INNER WEST COUNCIL

DEVELOPMENT ASSESSMENT REPORT

Application No.	D/2018/189
Address	67 Ballast Point Road, BIRCHGROVE NSW 2041
Proposal	Lower ground, ground and first floor alterations and additions to existing dwelling-house, and associated works, including construction of a new swimming pool at rear, tree removal and replacement of a shed.
Date of Lodgement	17 April 2018
Applicant	Vaughan Architects Pty Ltd
Owner	Mr R L Freeman and Mrs K J Freeman
Number of Submissions	Objections from 6 properties
Value of works	\$957,500
Reason for determination at Planning Panel	Demolition of a portion of the heritage item
Main Issues	Impacts to heritage item Bulk and scale Impacts to trees on adjoining properties Visual privacy
Recommendation	Deferred commencement
Attachment A	Recommended conditions of consent
Attachment B	Plans of proposed development
Attachment C	Statement of Heritage Significance

Figure 4: Photograph taken during site inspection (4 September 2018). Note the new internal staircase and new wall opening (Source: Inner West Council)

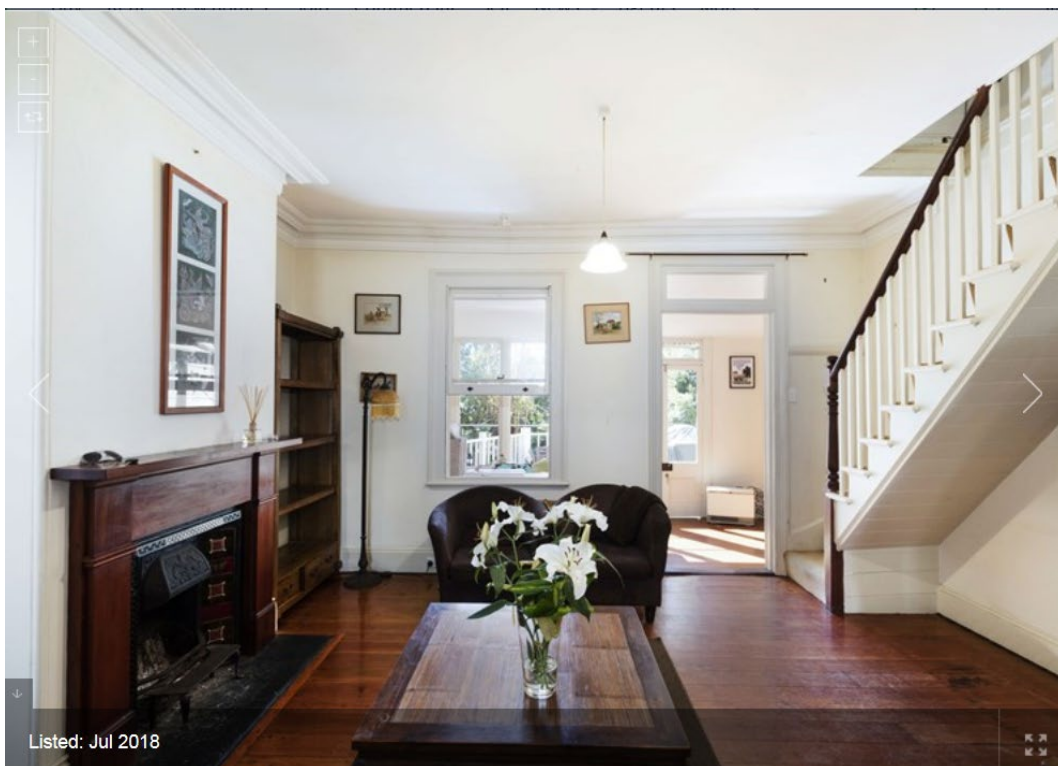
Original staircase and wall removed	<p>Unauthorised works such as removal of the original staircase and adjoining wall have been carried out to this property prior to lodging a pre-Development Application (see Figures 2 to 4). The documentation lodged at pre-DA stage has used the presence of non-original fabric as an argument to gain support for a first floor roof link and removal of the existing staircase.</p> <p>Removal of this original significant fabric without consent cannot be justified from a heritage perspective and this action has diminished the significance of this item. There is a concern that acceptance of these unauthorised works could establish an adverse precedent for other heritage items within Inner West Council and bring to further loss of significant fabric. A compliance process should follow after the DA is determined and the removed wall should be reinstated to its former detail. There are difficulties in requiring the reinstatement of the staircase in its original form, as it would not comply with the BCA, and the installation of a compliant stair would create additional adverse heritage impacts.</p> <p>Proposed interpretation measures for the staircase are based on paint treatment to the wall and markings on the floor to reflect the original staircase alignment. These will be included as a condition of consent.</p> <p>It is also recommended that the existing stairwell opening be retained as part of the interpretation of the former stair, with the addition of a balustrade at first floor level as a safety measure. This will be added to the subject conditions of consent.</p>

1. The wall to the northern side of the staircase that was recently demolished shall be reinstated to its former detail, complete with door frame, architraves, threshold and transom light. Detailed drawings shall be submitted to Council showing the proposed reinstatement prior to the issue of a Construction Certificate. Prior to the issue of an Occupation Certificate, the wall must be reinstated in accordance with the Construction Certificate Plans. Supporting documentation prepared by a suitably qualified Heritage Architect confirming the reinstatement is consistent with the CC plans including photos must be submitted to the Certifying Authority prior to the issue of an Occupation Certificate.

2. The removed staircase shall be interpreted through the following measures:
 - (a) Use of matt polish over the timber floor of a different hue than the rest of the room;

- (b) The retention of the rectangular shape cut in the ground floor and the marking of the newel post location and form;
 - (c) The permanent marking on the wall of existing shadow lines to mark the previous stair's stringer;

- (d) Retention of the stairwell void without infill;
 - (e) Enclosure with a balustrade at first floor level as a safety measure.

PROJECT: 67 BALLAST POINT RD, BIRCHGROVE. ALTERATIONS AND ADDITIONS
DATE: 13.08.18
SCALE: As indicated
DRAWN BY: Author
ISSUE: 2
DRAWING NO: DA11
PROJECT NO: Project Number

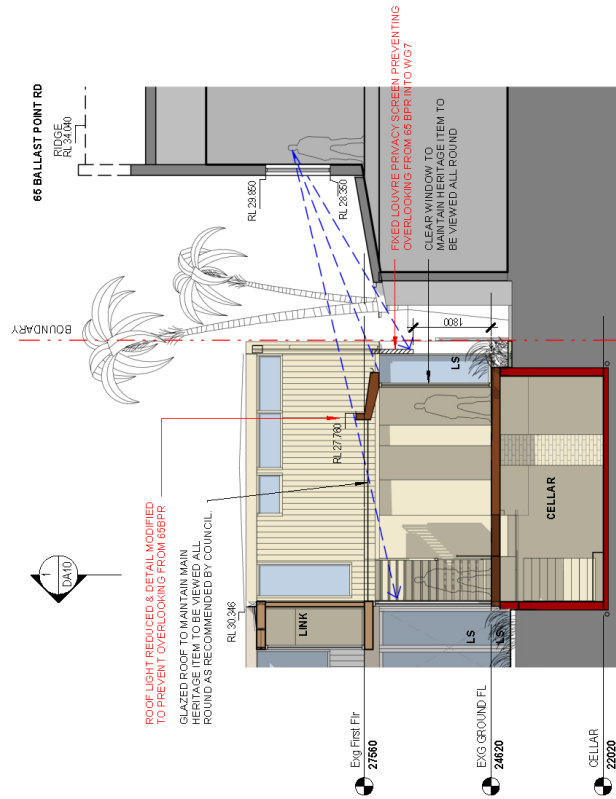
- b) The proposed pool is to be deleted from the proposal.
 - c) The privacy screens on the eastern and western sides of the first floor balcony are to have 1 metre returns on the north side of the balcony.

PROPOSED STAIR INTERPRETAION, EAST WALL EXISTING LOUNGE

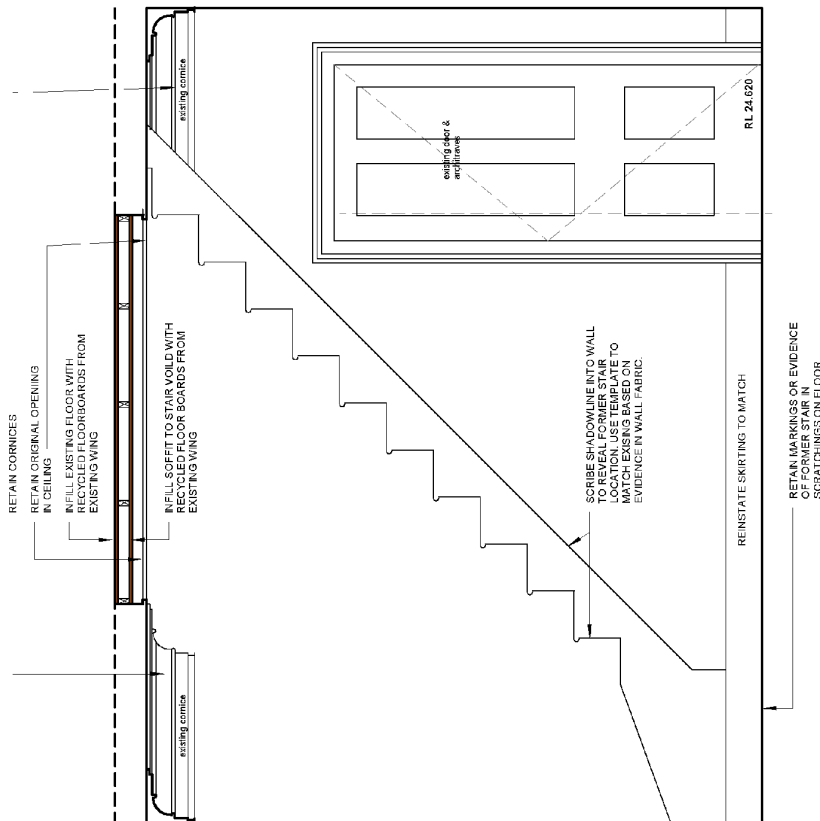
After consideration of the additional information provided, there are difficulties in requiring the reinstatement of the staircase in its original form, as it would not comply with the BCA, and the installation of a compliant stair would create additional adverse heritage impacts.

Proposed interpretation measures for the staircase are based on paint treatment to the wall and markings on the floor to reflect the original staircase alignment. These will be included as a condition of consent. It is also recommended that the existing stairwell opening be retained as part of the interpretation of the former stair, with the addition of a balustrade at first floor level as a safety measure.

A full interpretation methodology outlining details of finishes, sections and plans of this task, including the permanent engraving/markings on the wall, timber floor matt finish, proposed balustrade and wall treatment shall be prepared prior to the issue of a Construction Certificate. Any infill of the stair void visible on DA22 drawing shall be deleted from the plans. Supporting documentation, including photographs, prepared by a suitably qualified Heritage Architect confirming the installation of the interpretation is consistent with the CC plans must be submitted to the Certifying Authority prior to the issue of an Occupation Certificate.
